Your ref: Docket No. 52-006
Our ref: DCP/NRC1599

SUBJECT: Transmittal of Westinghouse Responses to Open Items Identified in the AP1000 Draft Safety Evaluation Report

Westinghouse Non-Proprietary Response to AP1000 Draft Safety Evaluation Report (DSER) Open Items

AP1000 DESIGN CERTIFICATION REVIEW

Figure 19A.2-8-1: Floor Response Spectra of ASB Node at EL. 116.50'

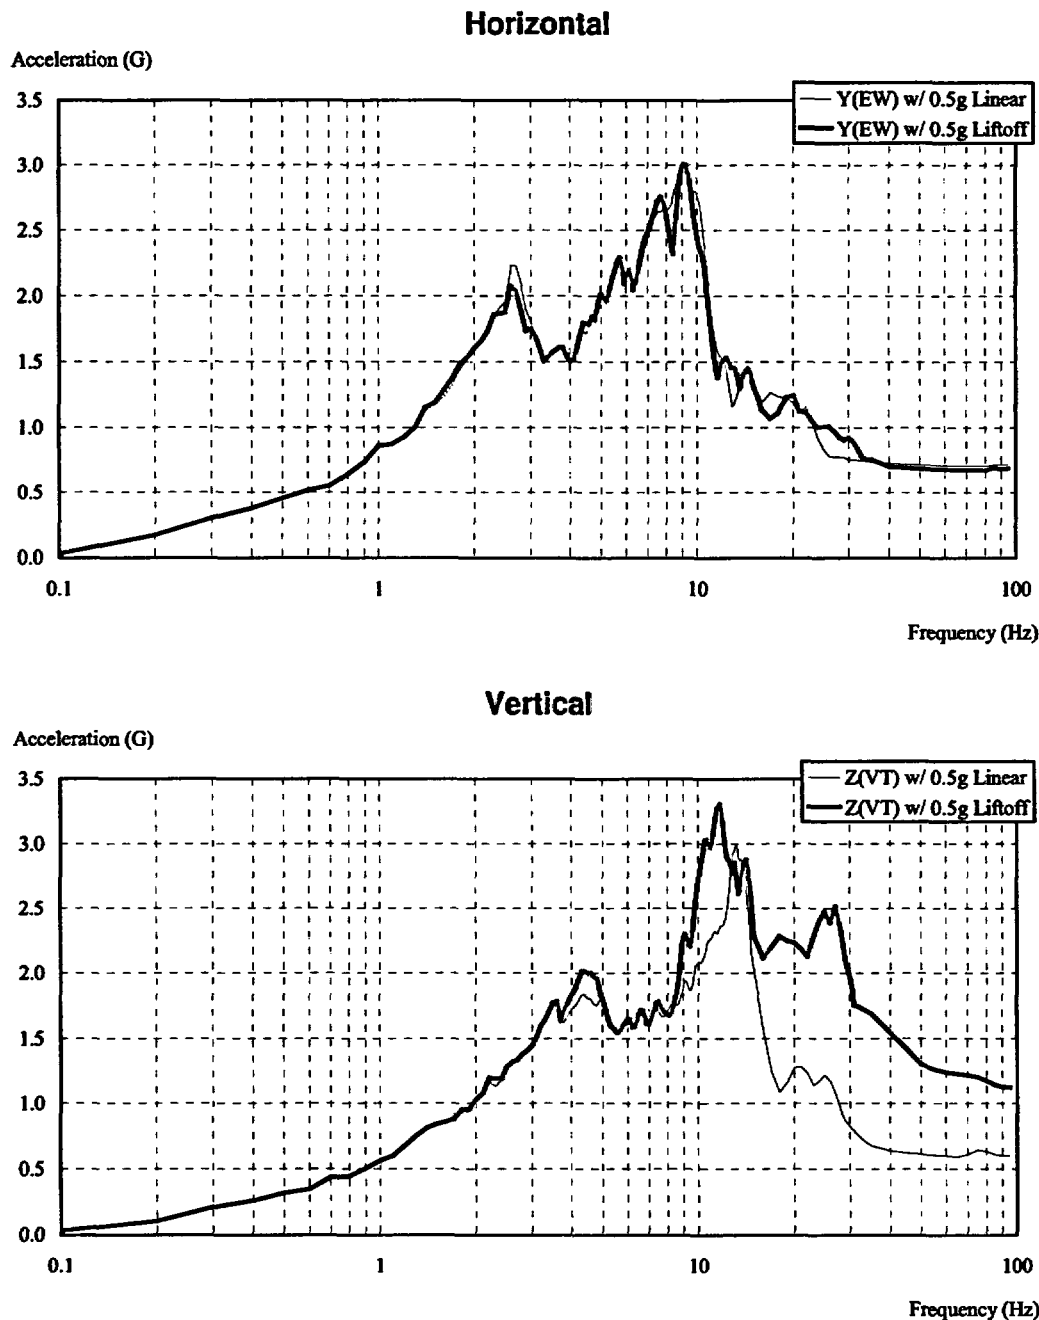
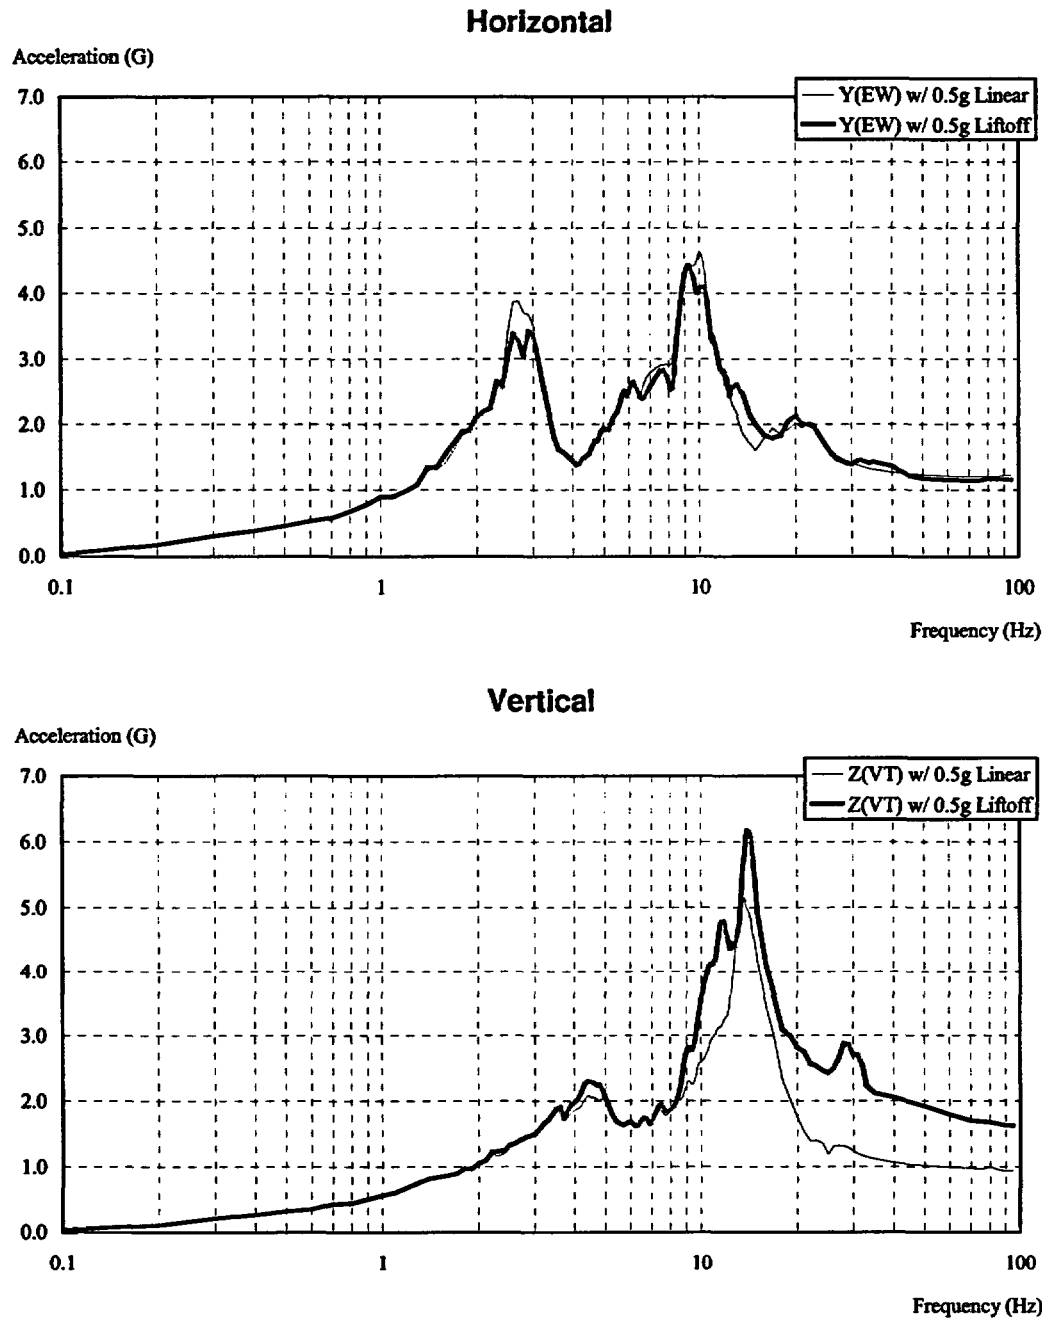
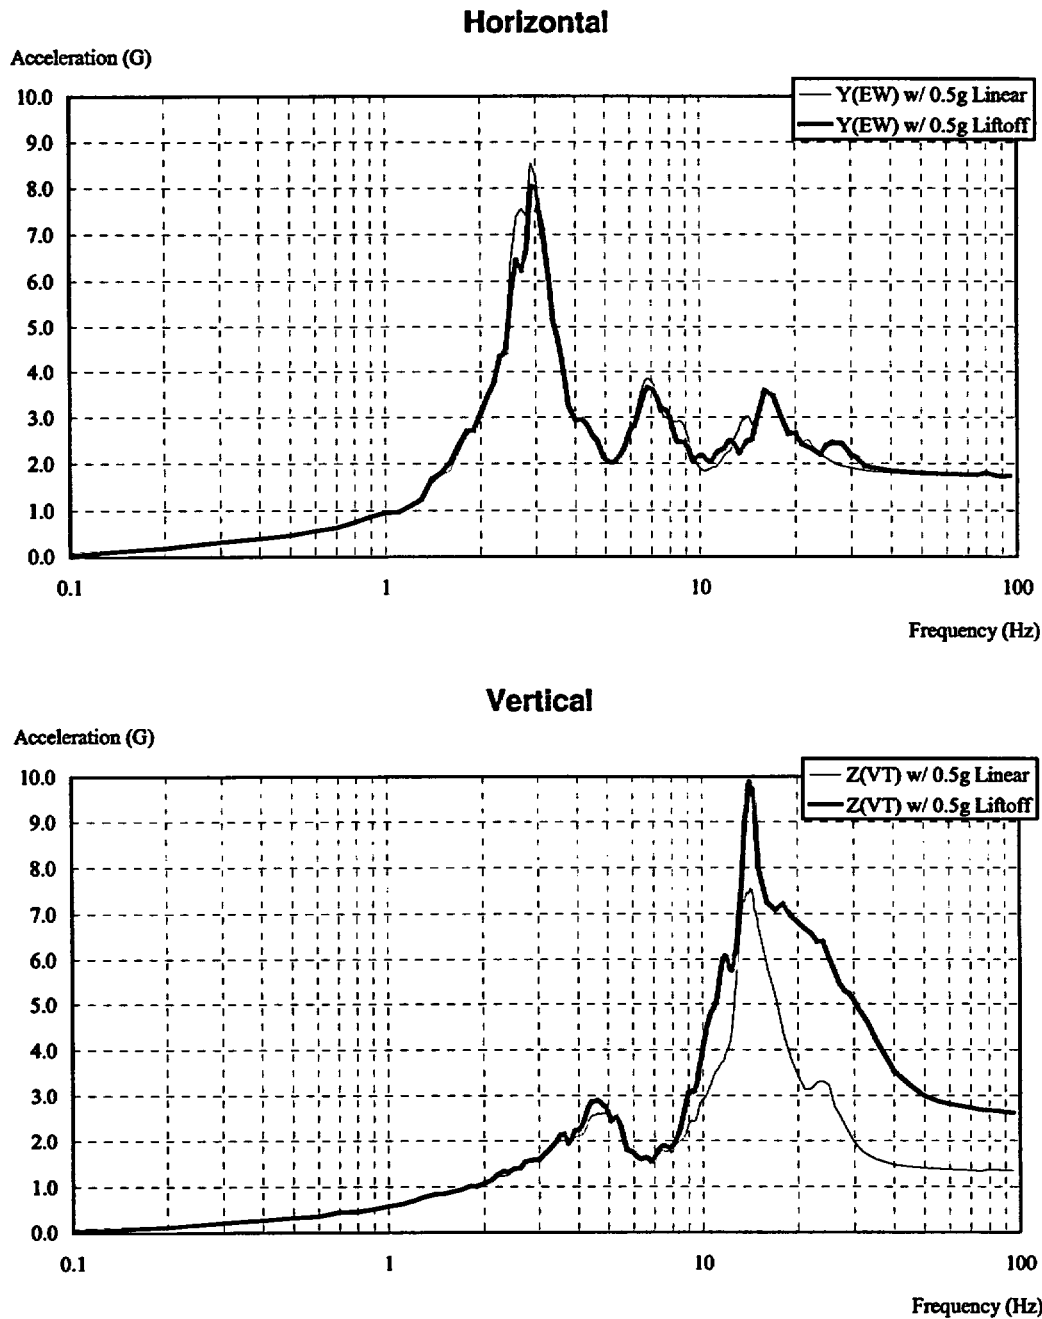
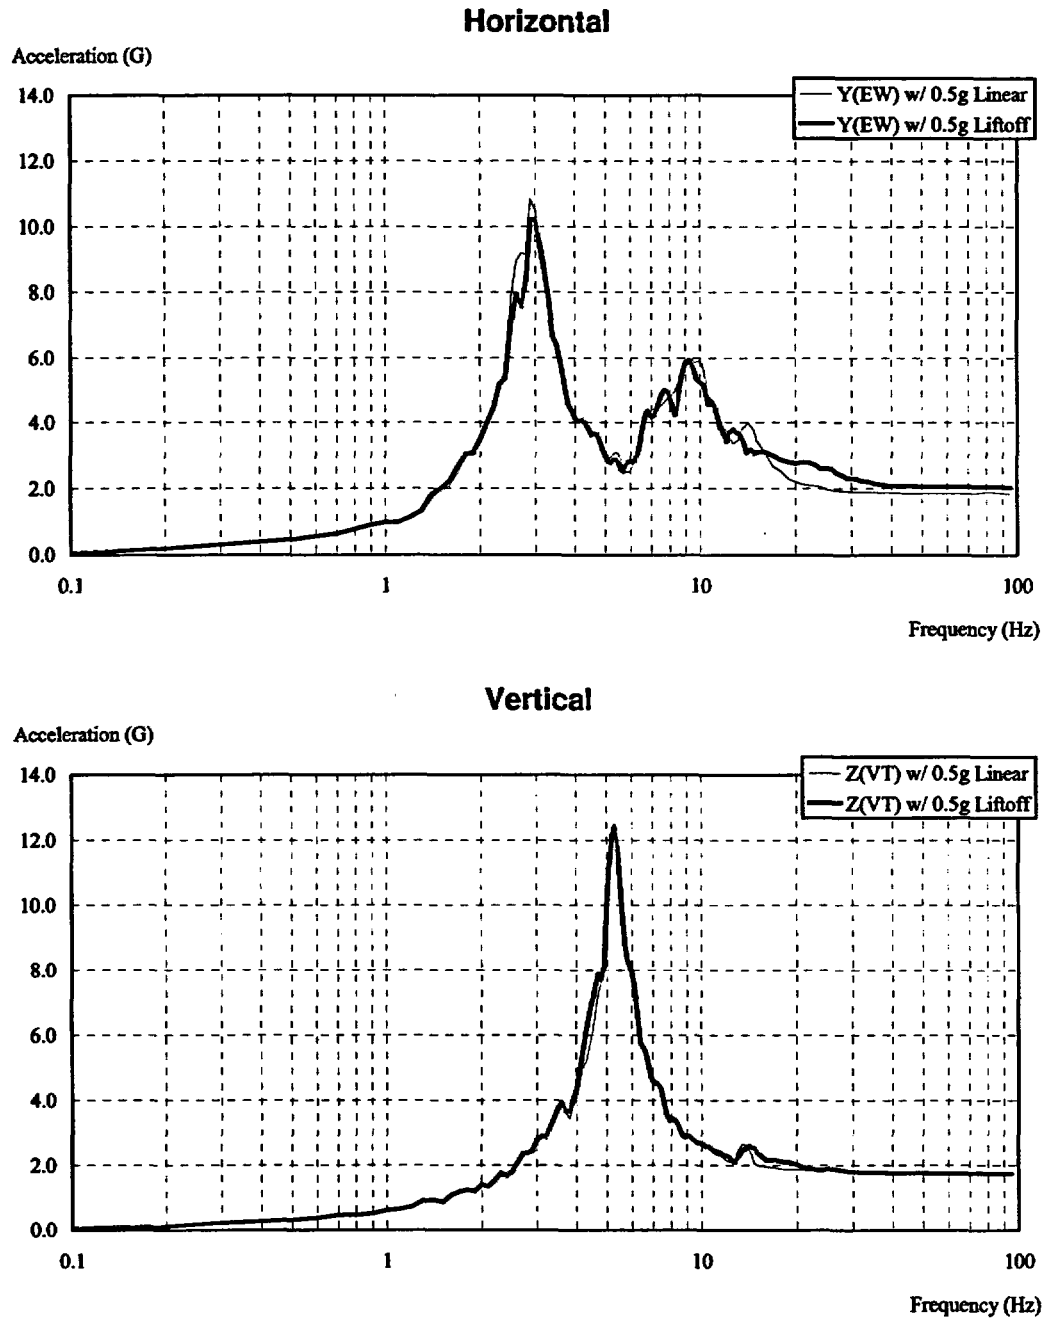
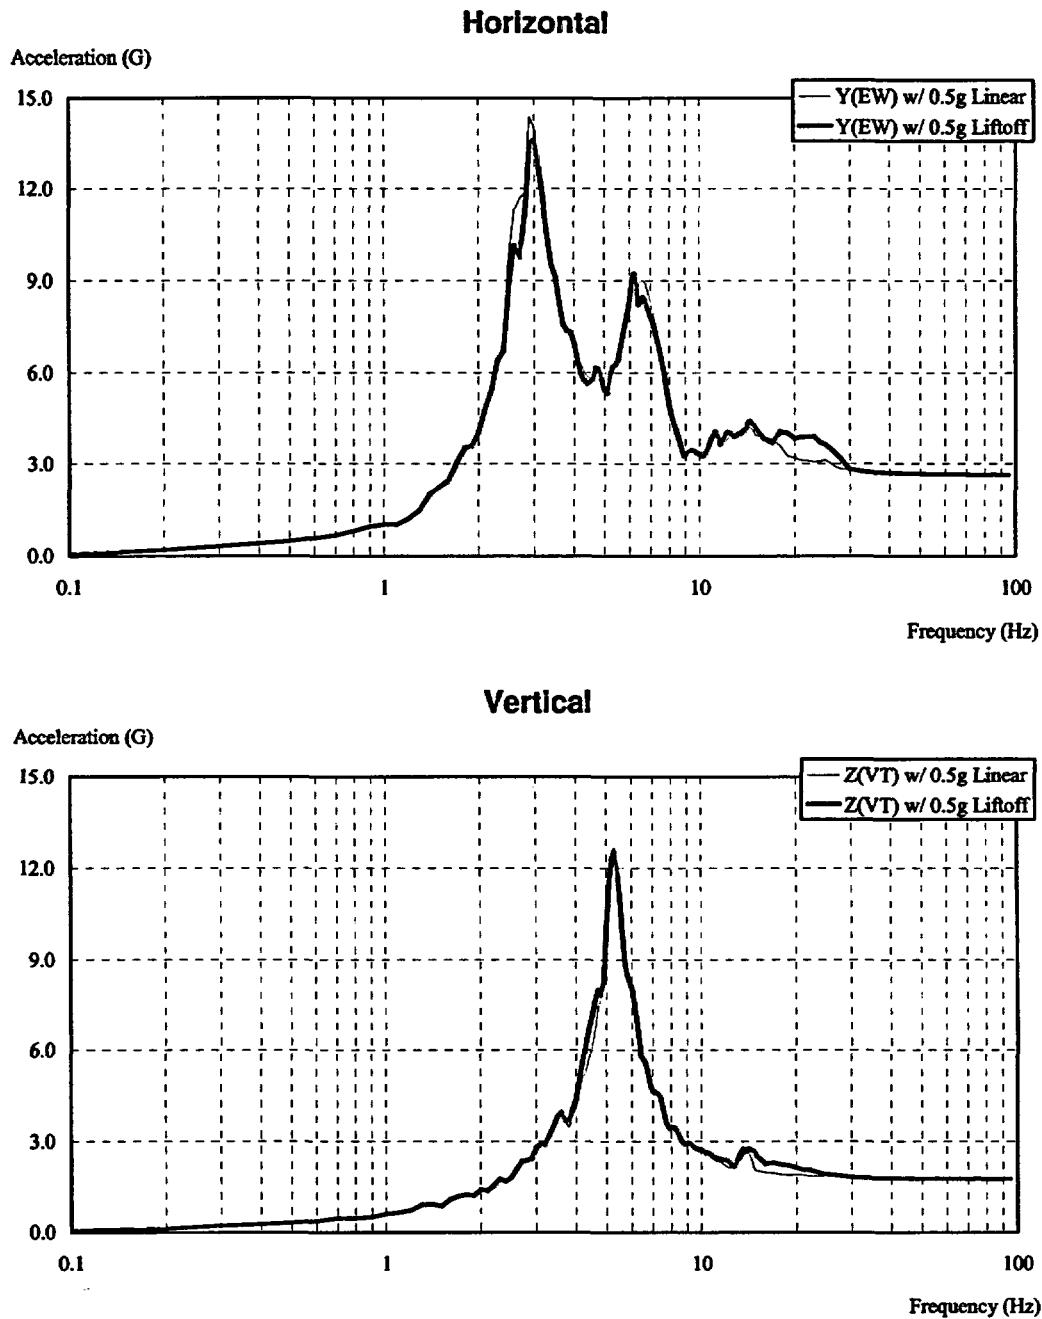
The applicant used the deterministic approach to estimate the HCLPF values of primary system component supports. The components included in the approach are: polar crane, baffle plate supports, heat exchanger for the passive residual heat removal system, core makeup tank and valves. The applicant used lower bound values, and it appears that there was no need for invoking factors of conservatism to arrive at the HCLPF values. It is noted that the core makeup tank has a HCLPF value of 0.54g; therefore, any increase in seismic response of the containment internal structure due to lift off of the internal structure or the nuclear island structure would necessitate a review of this HCLPF value. This is Open Item 19A.2-8.

The effects of basemat uplift have been evaluated for AP1000 using seismic time history analyses. Peak accelerations, floor response spectra, and member forces from seismic time history analyses that included basemat uplift were compared to seismic time history analyses that did not include lift off. The comparisons show that the basemat uplift effect is insignificant. Results and discussion are given in DSER Open Item Number 3.7.2.3-1.

In order to make conclusions for higher seismic events ($> 0.3g$), seismic response spectra (@5% equipment damping) were developed for the 0.5g case. Response spectra that include nonlinear liftoff effects were developed at different elevations using the auxiliary shield building (ASB) stick model described in DSER Open Item Number 3.7.2.3-1. The maximum uplift of the basemat is 0.29". In Figures 19A.2-8-1 to 19A.2-8-5 comparisons are made of these response spectra to the seismic response spectra using the linear ASB stick model. As seen from this comparison liftoff is not significant for horizontal response since the horizontal response spectra are similar. In the region of the shield building roof the vertical response spectra are comparable. There are differences in the vertical response spectra in the higher frequency region for the Shield Building cylinder up to elevation 265'. However, the differences shown in these curves will not affect the HCLPF values because:

- High frequency content due to impact is not damaging
- High frequency seismic response is limited to the cylinder portion of the Shield Building
- Side soil effects, not considered in overturning study, will have significant effect on liftoff
